# Town of Gorham Planning Board Meeting May 6, 2024

**ITEM 5 - Discussion – Preliminary Subdivision – Ali Omur & Carmen Schneider – 79 Day Road Subdivision** – a request for approval to divide a parcel split by previous landowner with outsale lots 1 and 2. The current proposal is to create two additional lots for single-family homes. Map 23, Lot 7. Zoned UREXP. The applicant is represented by Andrew Morrell, P.E., with BH2M.

**Wright-Pierce:** 4/29/2024

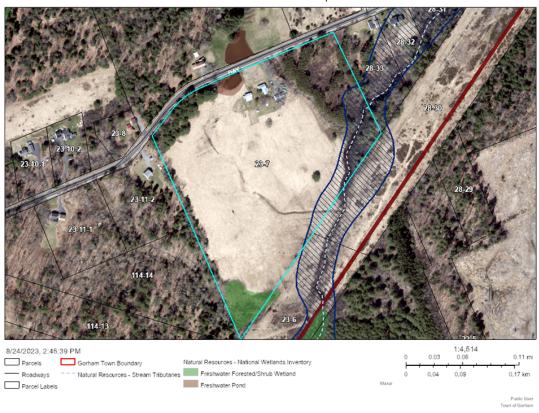
- A tributary of Indian Camp Brook passes through the rear of the proposed Lot 3.
- The area adjacent to the stream tributary is mapped as a FEMA flood plain.
- The Maine Beginning with Habitat Map Viewer does not show the presence of any rare wildlife or plant communities within the subdivision area.
